AMENDMENT DRAWING

AMENDMENT DRAWING

Project Title: VA PUGET SOUND HEALTH CARE SYSTEM UPGRADE SEATTLE ELECTRICAL DISTRIBUTION FROM 5kV TO 15kV

Drawing Number: 100-EP602T4R

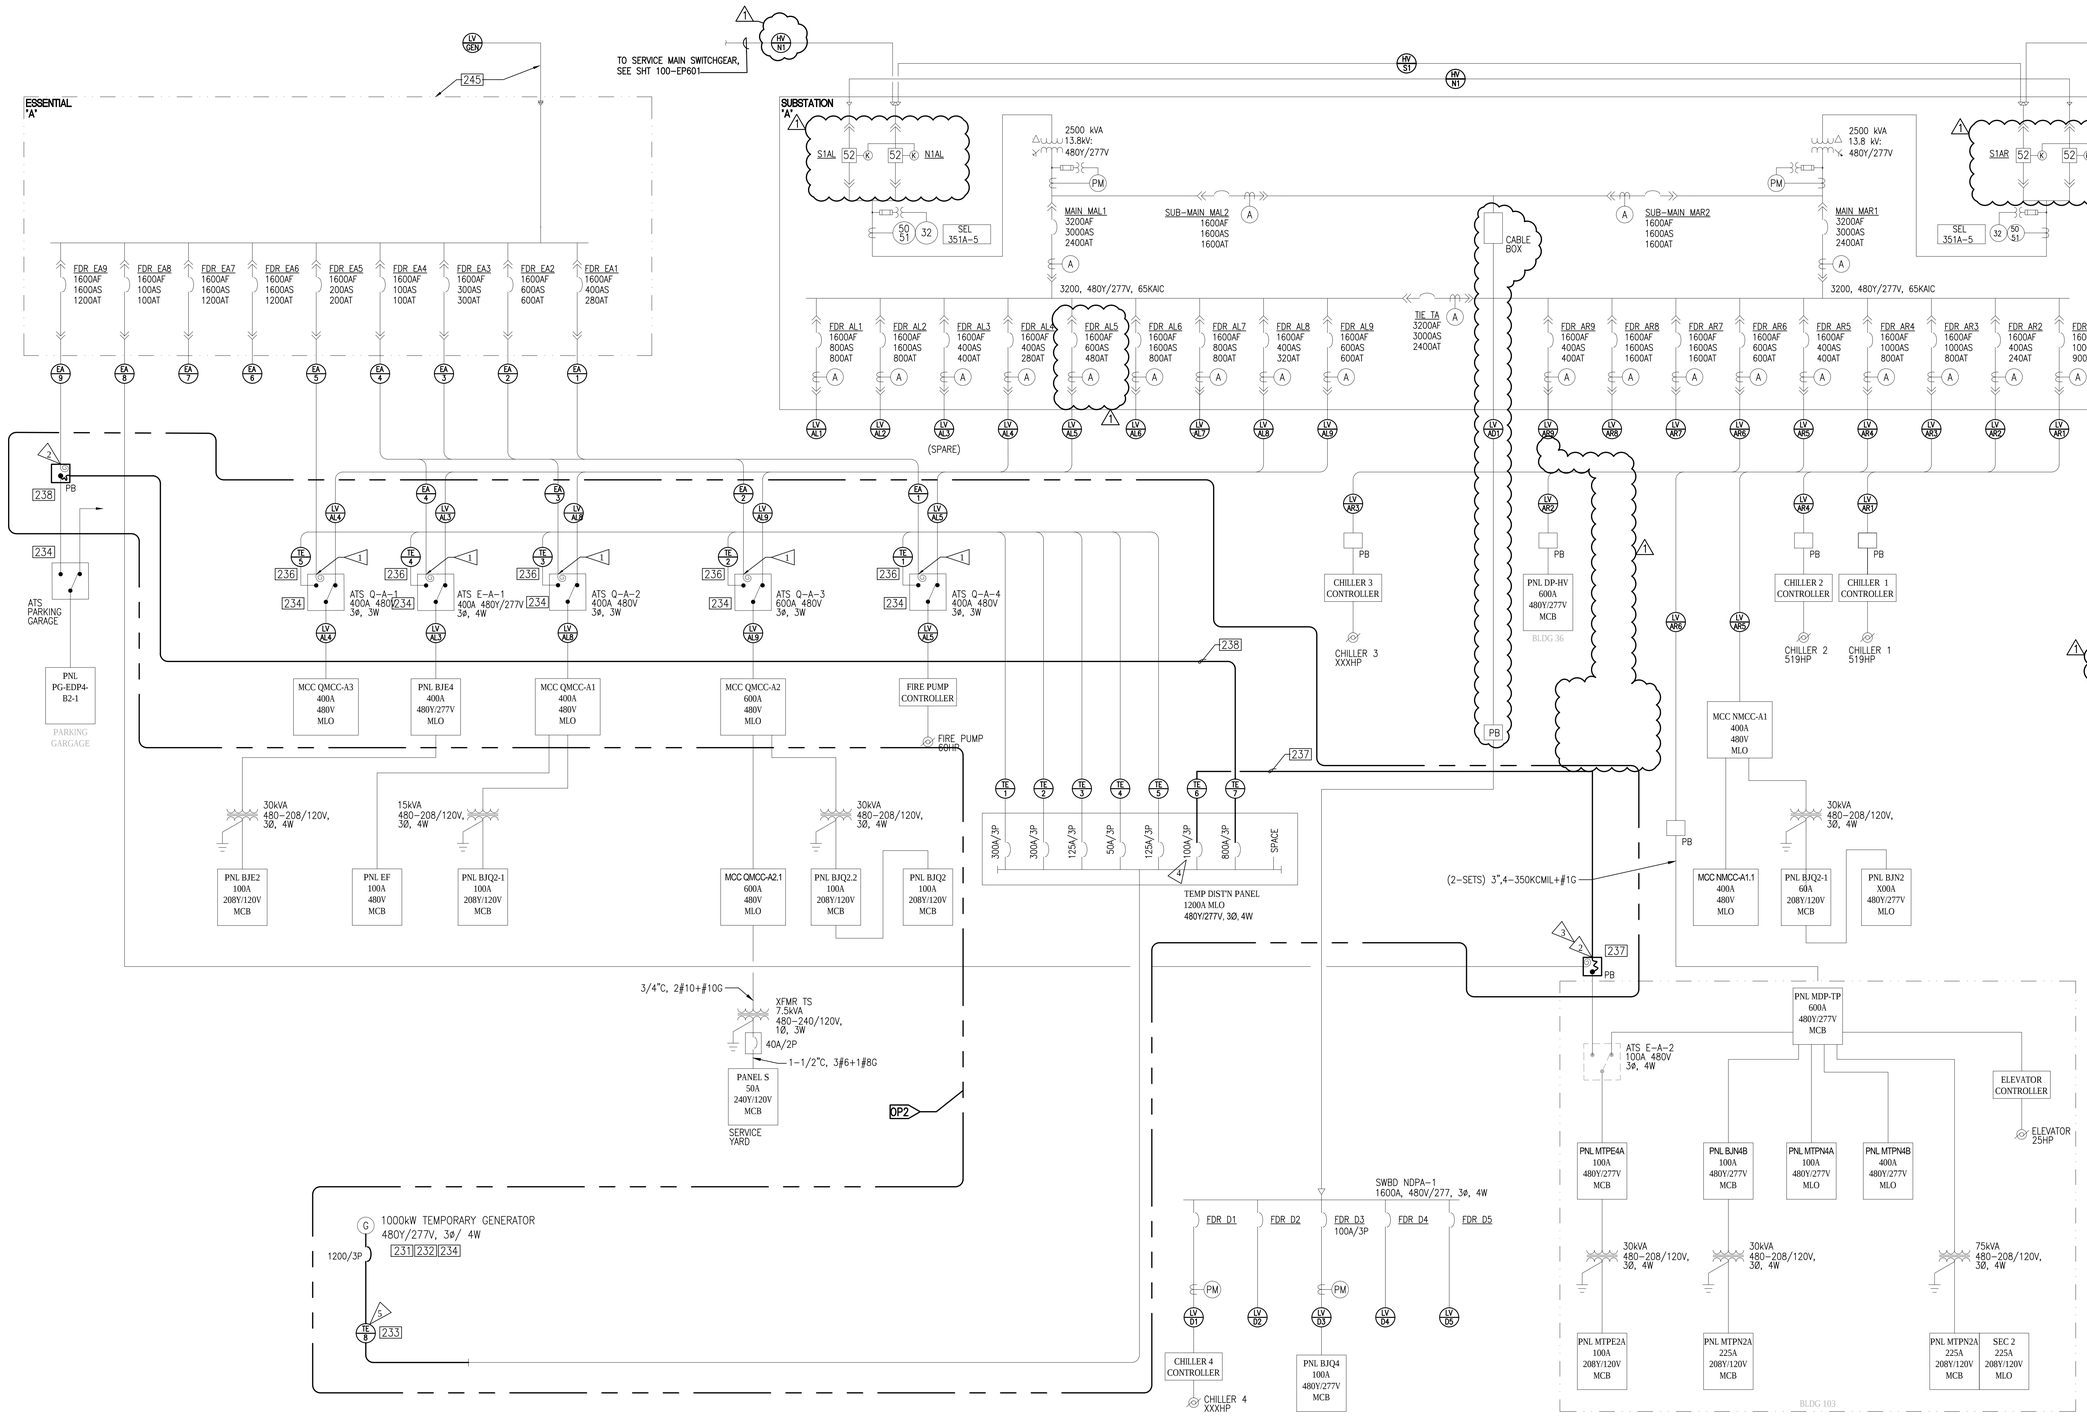
1. DISCONNECT EXISTING FEEDER. MAKE SAFE FOR RE-USE.
2. INTERCEPT EXISTING FEEDER. PROVIDE DUAL RATED, AL/CU SPLICE KIT.
3. PROVIDE J-BOX.
4. PROVIDE CIRCUIT BREAKER SIZE AS SHOWN.
5. RECONNECT EXISTING TEMPORARY FEEDER TO GENERATOR.

Drawing Number: 100-EP602T5R

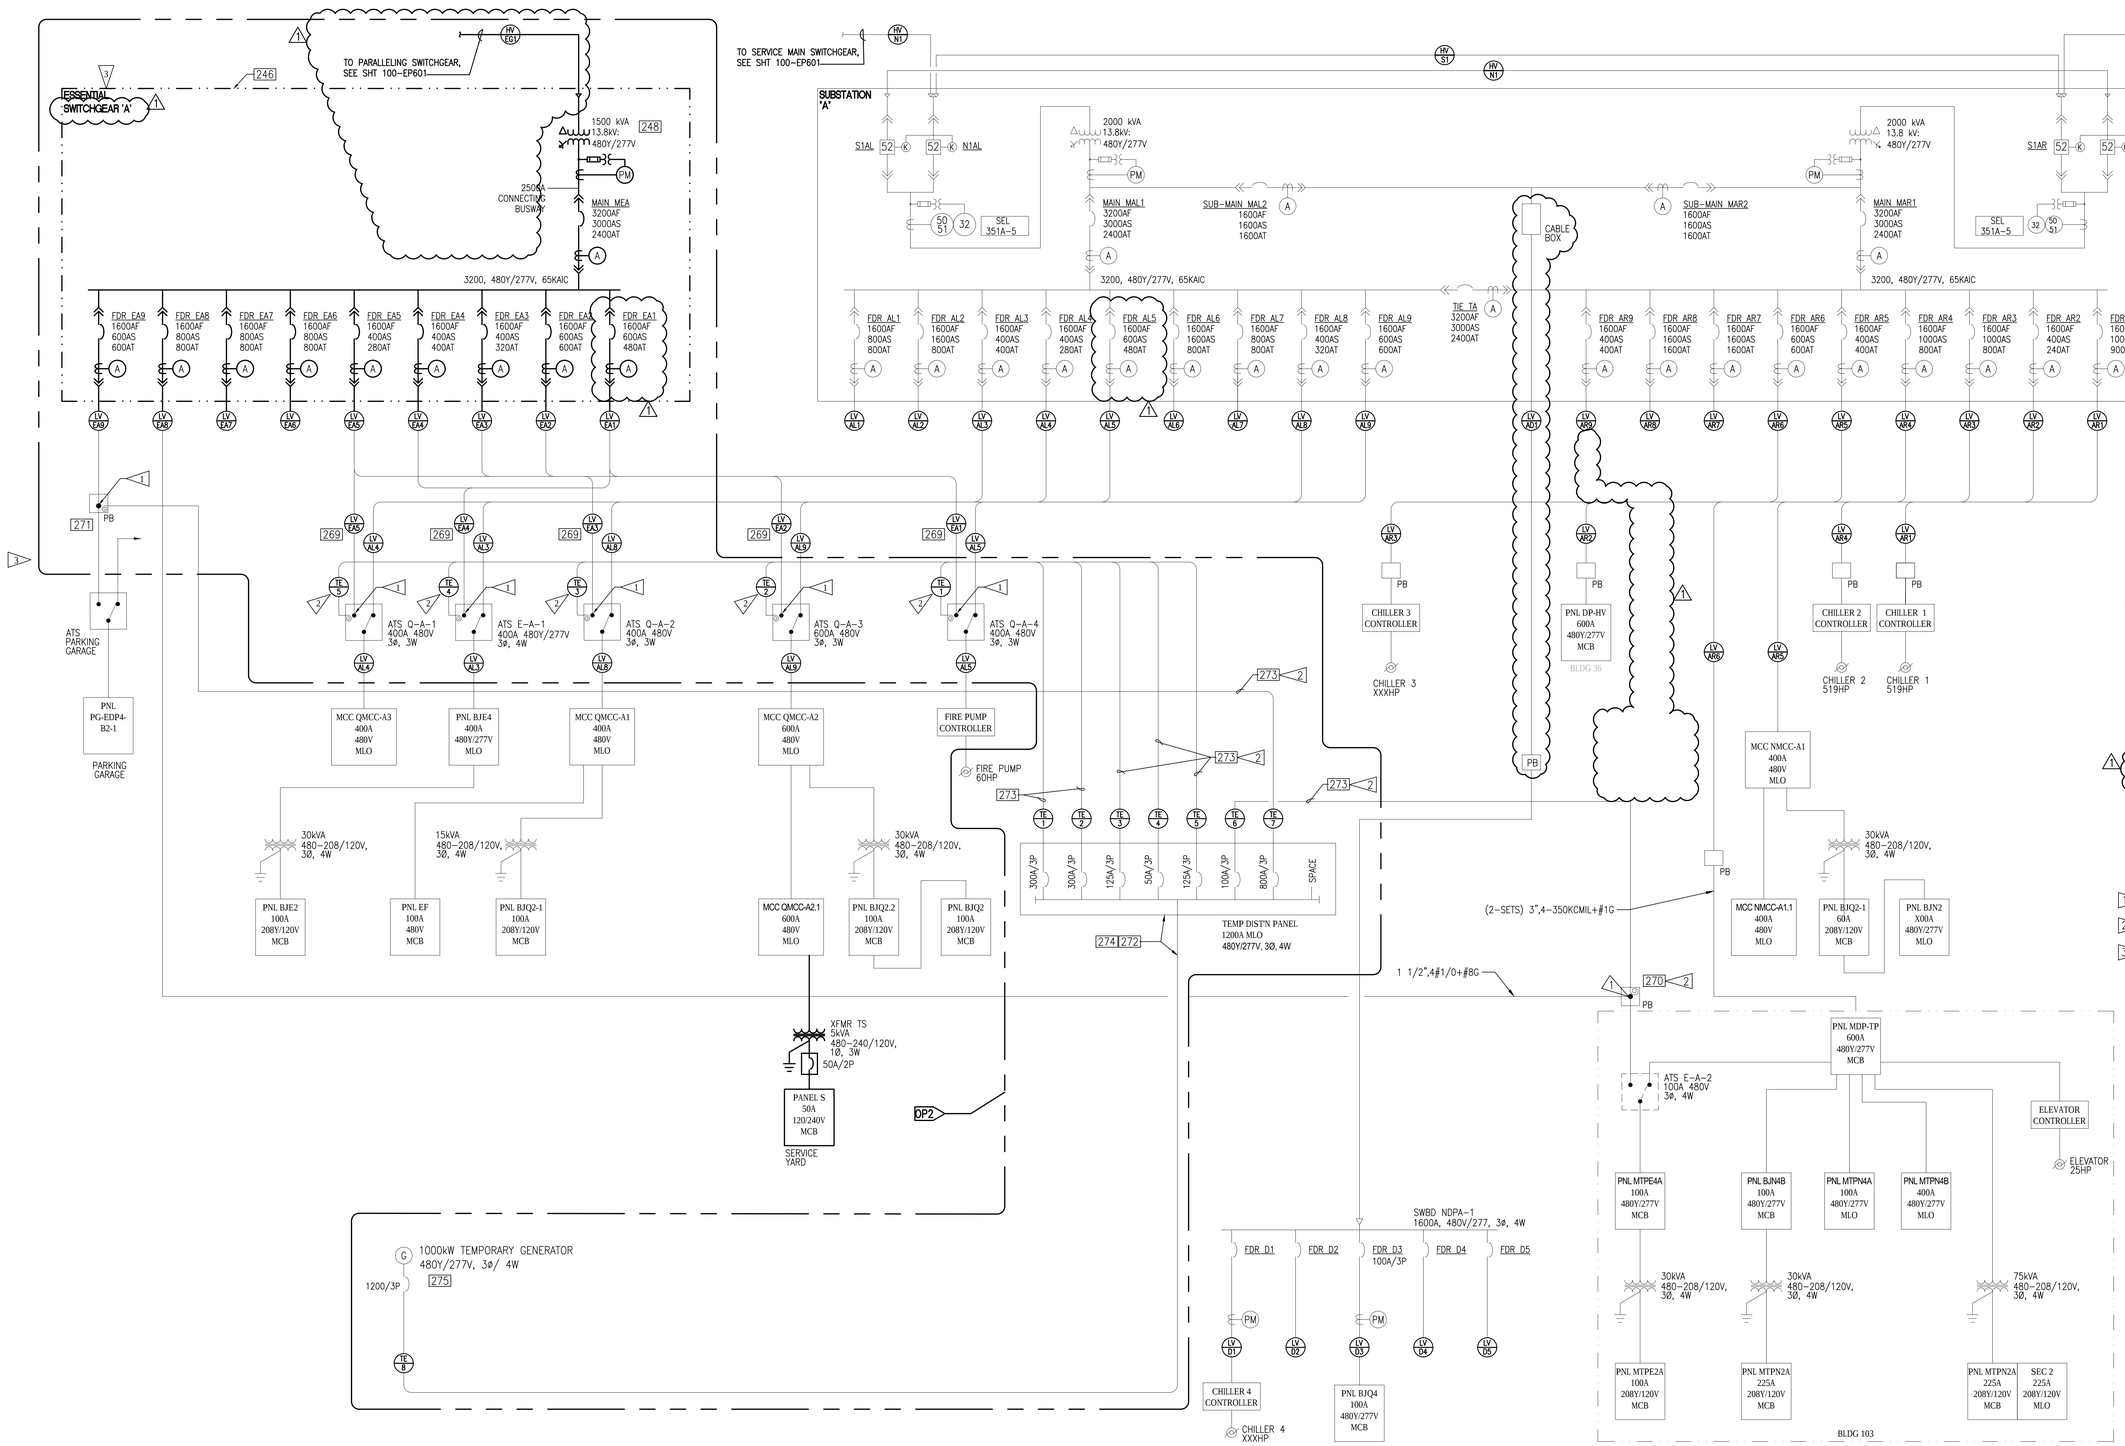
1. RECONNECT PERMANENT FEEDER.
2. REMOVE TEMPORARY FEEDER.
3. SET LONG TIME PICKUP TO "AT" VALUE SHOWN FOR EACH BREAKER IN LOW VOLTAGE SWITCHGEAR. SET ALL OTHER TRIP UNIT ADJUSTMENTS TO VALUES FROM COORDINATION STUDY PER SPEC SECTION 260573.

Project Number: 663-15-102
Building Number: 100
Drawing Number: 100-EP603T1
Dwg. -- of --

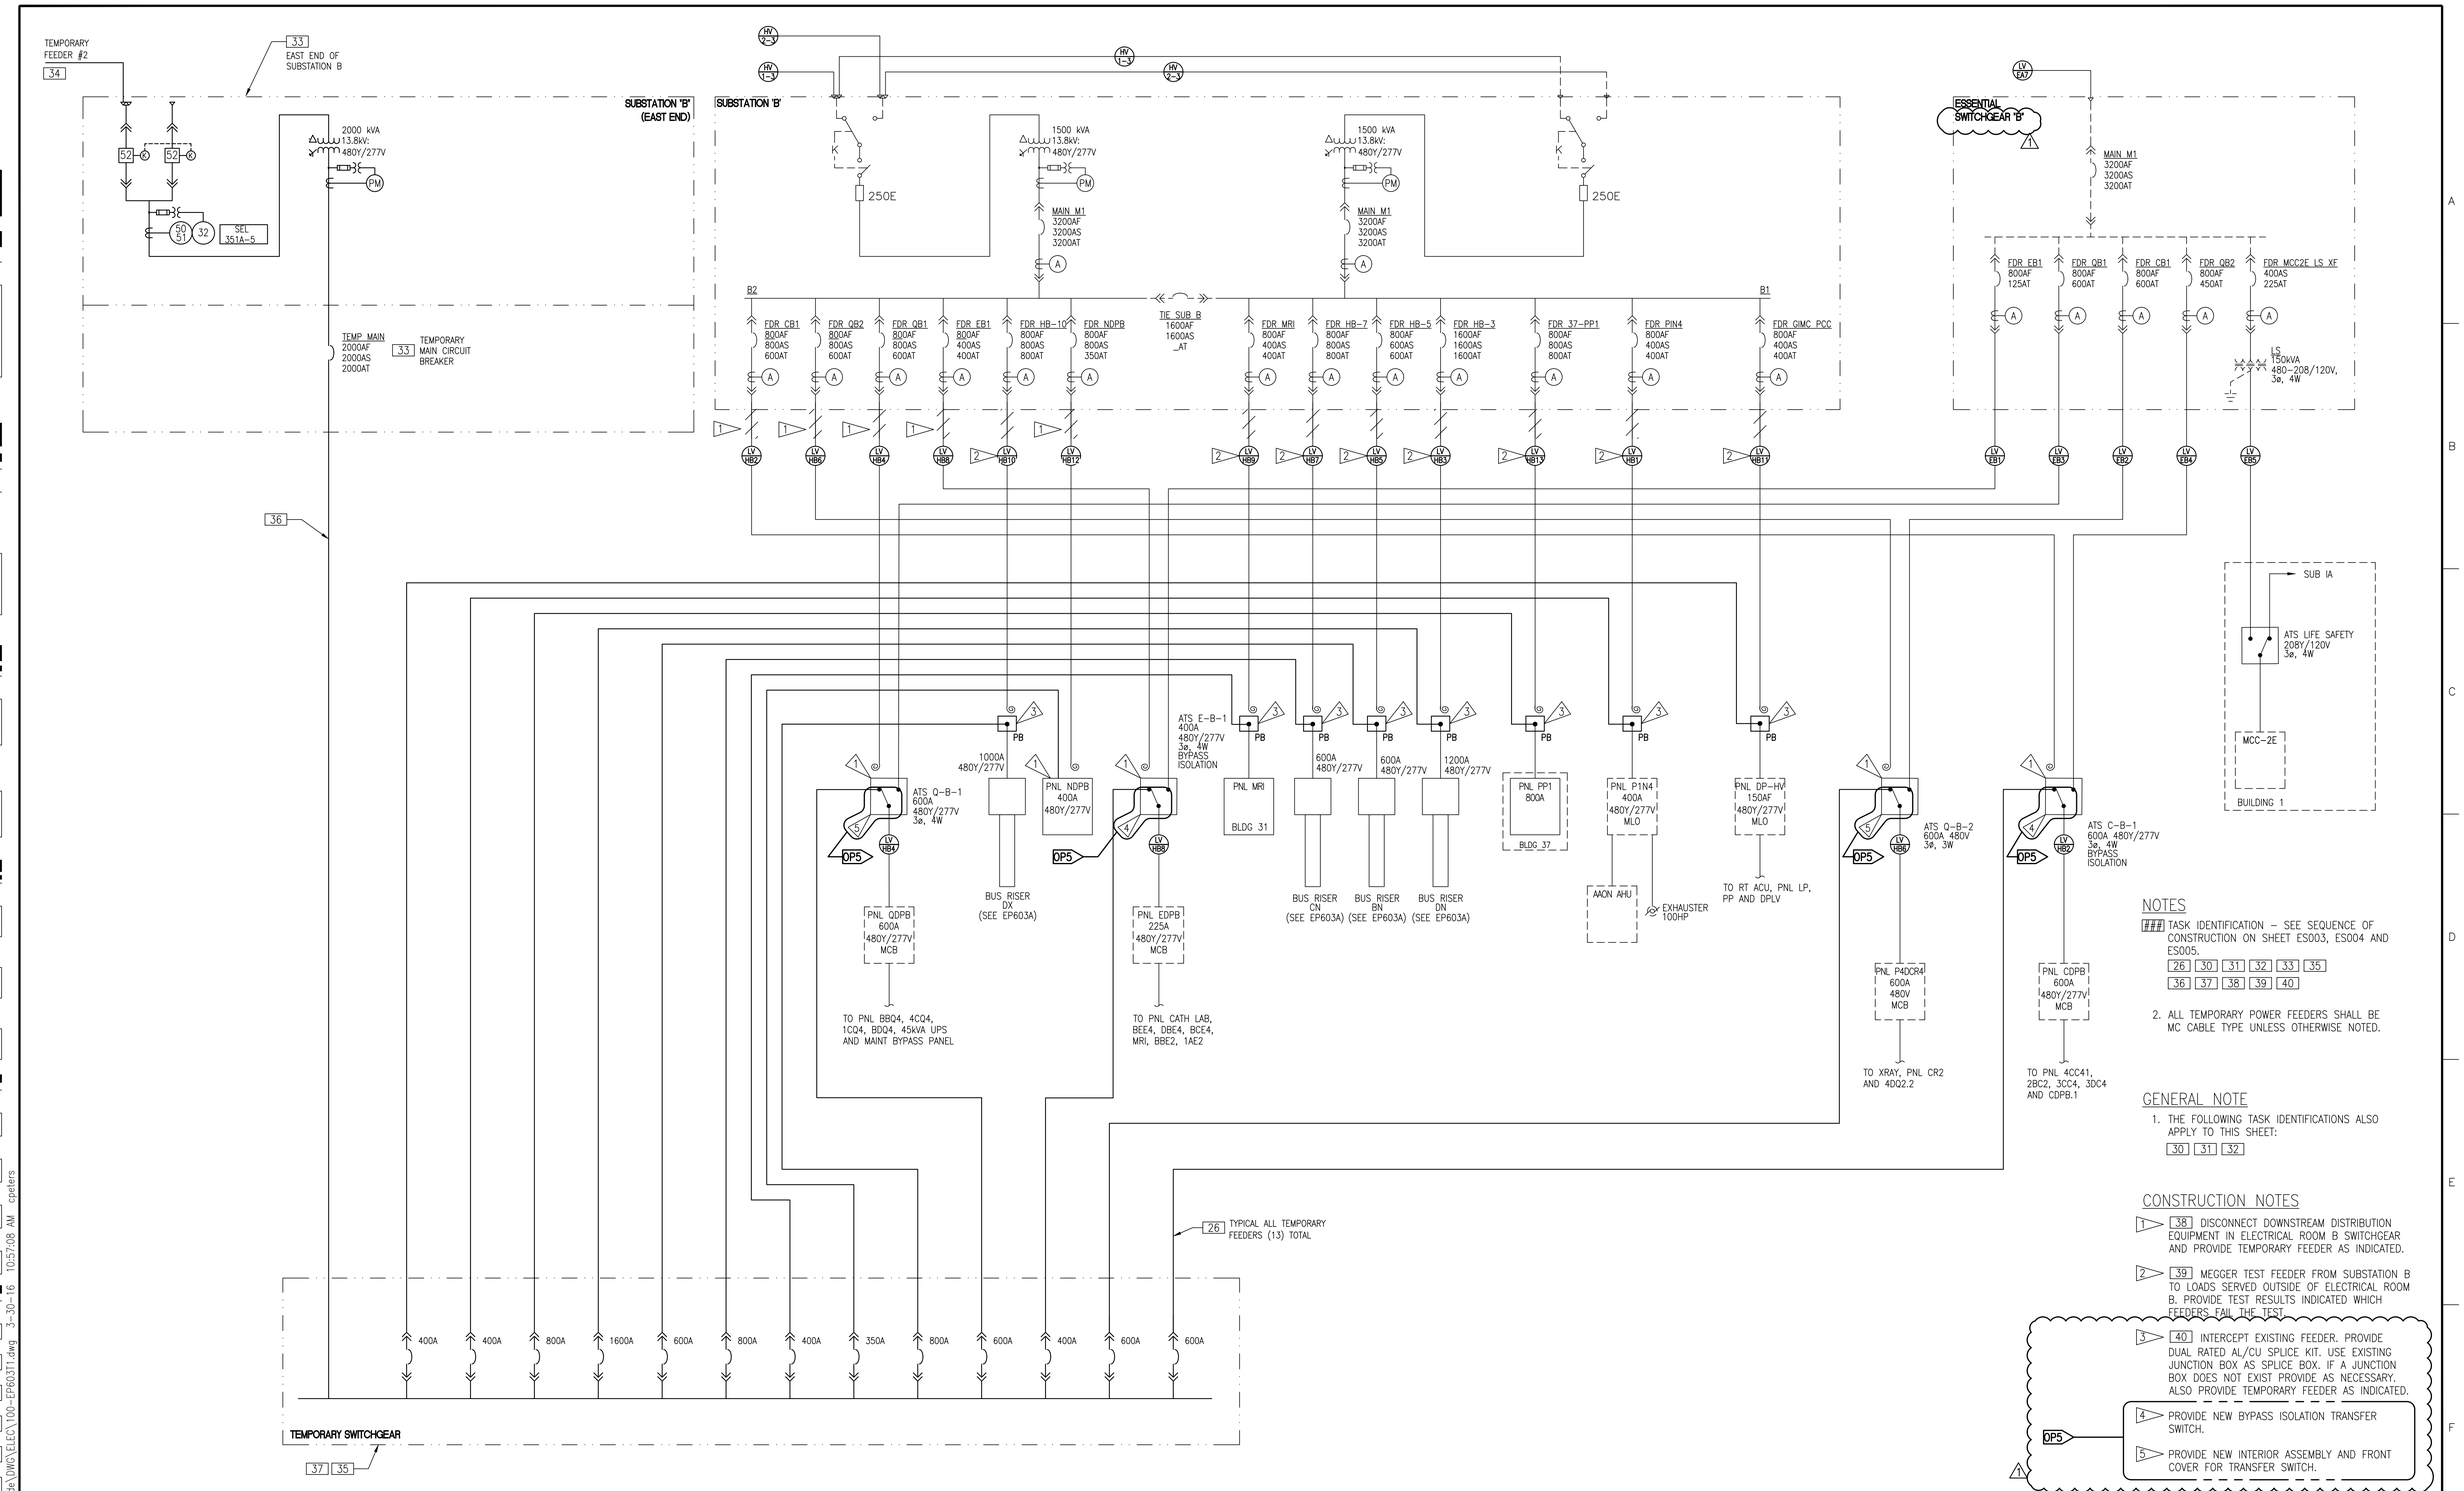
1 38 DISCONNECT DOWNSTREAM DISTRIBUTION EQUIPMENT IN ELECTRICAL ROOM B SWITCHGEAR AND PROVIDE TEMPORARY FEEDER AS INDICATED.

2 39 MEGGER TEST FEEDER FROM SUBSTATION B TO LOADS SERVED OUTSIDE OF ELECTRICAL ROOM B. PROVIDE TEST RESULTS INDICATED WHICH FEEDERS FAIL THE TEST.

3 40 INTERCEPT EXISTING FEEDER. PROVIDE DUAL RATED AL/CU SPLICE KIT. USE EXISTING JUNCTION BOX AS SPLICE BOX. IF A JUNCTION BOX DOES NOT EXIST PROVIDE AS NECESSARY. ALSO PROVIDE TEMPORARY FEEDER AS INDICATED.

4 PROVIDE NEW BYPASS ISOLATION TRANSFER SWITCH.

5 PROVIDE NEW INTERIOR ASSEMBLY AND FRONT COVER FOR TRANSFER SWITCH.
